Product Change Notification / ASER-19HIWO872

CCB 4748 Final Notice: Qualification of MTAI as an additional assembly site for selected ATMEGA324PBxxx and PIC16F1xxx device families available in 44L TQFP (10x10x1mm) package.

CCB 4748
Pre and Post Change Summary
PCN #: ASER-19HIWO872

QUALIFICATION REPORT SUMMARY

Lead Frame Comparison

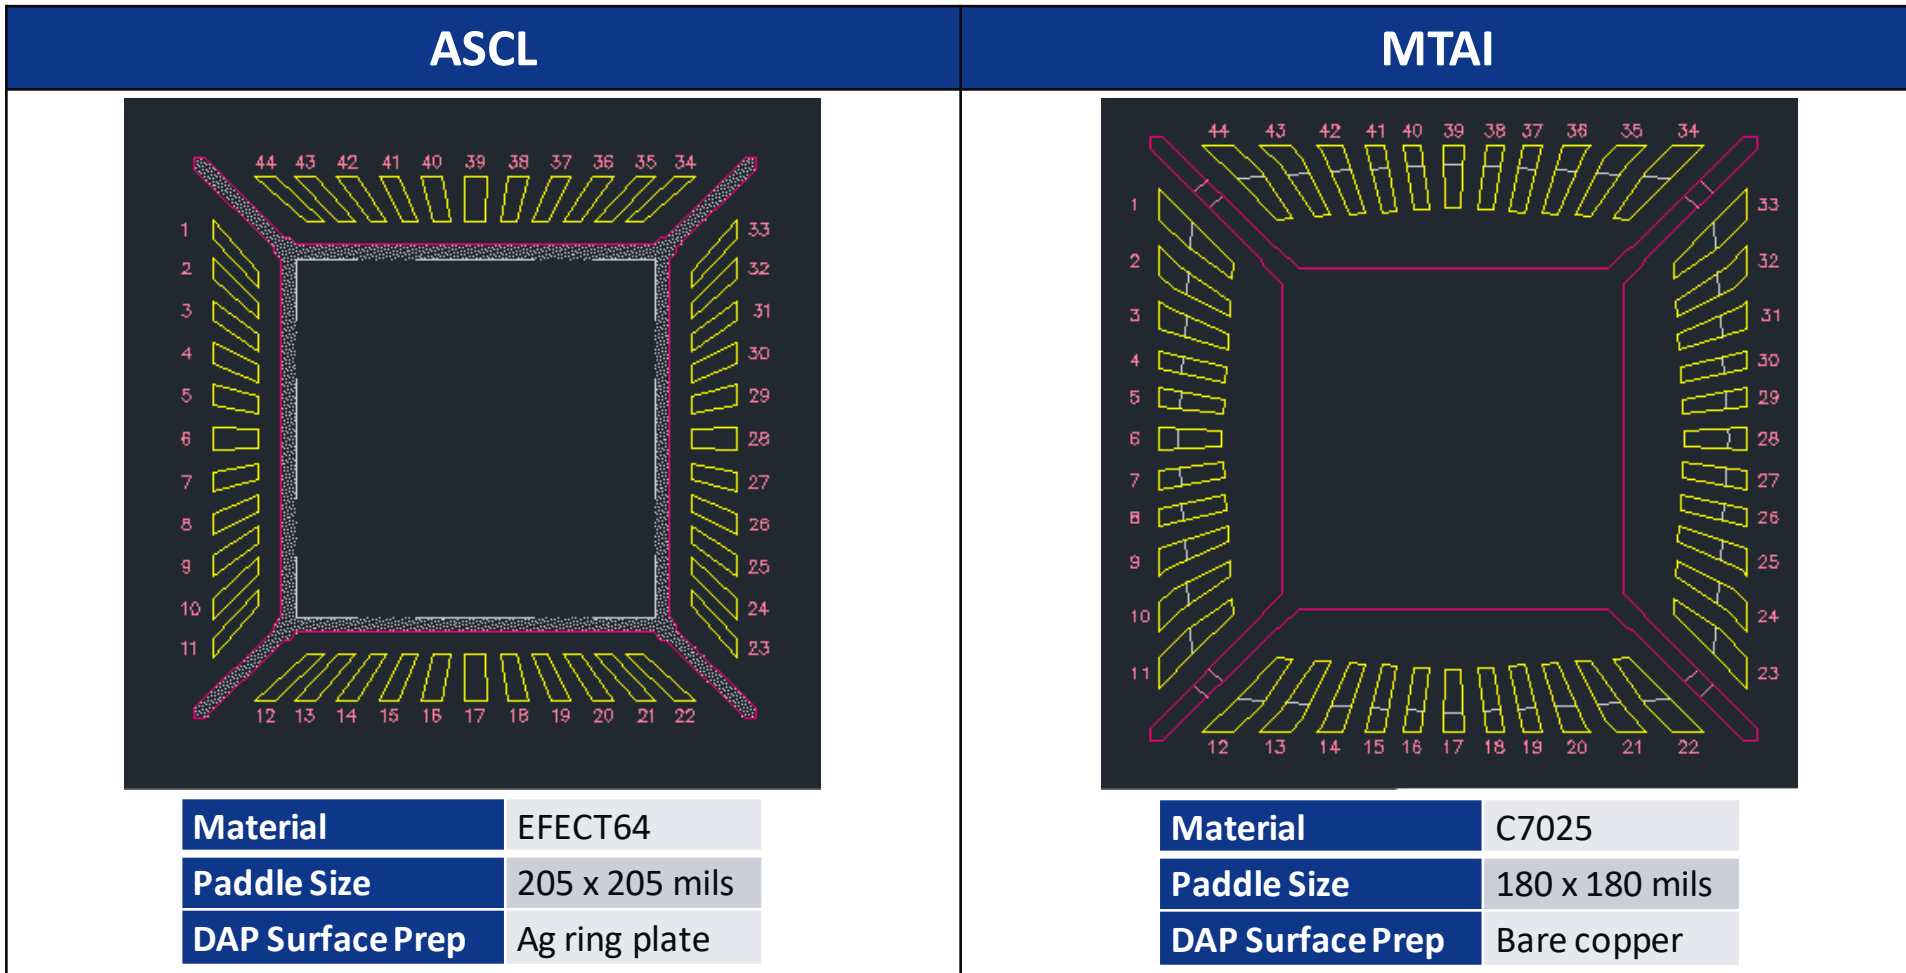
Assembly Site		ASE Group Chung-Li (ASCL)	ASE Group Chung-Li (ASCL)	Microchip Technology Thailand (MTAI)
Moisture Sensitivity Level (MSL)		MSL3	MSL3	MSL1
Shipping Media	Tray	Blue Bakeable	Blue Bakeable	Dark Blue Non-bakeable
	T/R	No Change	No Change	No Change
Wire Material		Au/CuPdAu	Au/CuPdAu	Au
Die Attach Material		EN-4900GC	EN-4900GC	3280
Molding Compound Material		G700	G700	G700
Lead Frame	Material	EFFECT64	EFFECT64	C7025
	Paddle Size	205 x 205 mils	205 x 205 mils	180 x 180 mils
	DAP Surface Prep	Ag ring plate	Ag ring plate	Bare Copper
	See Pre and Post Change Summary for Lead Frame comparison.
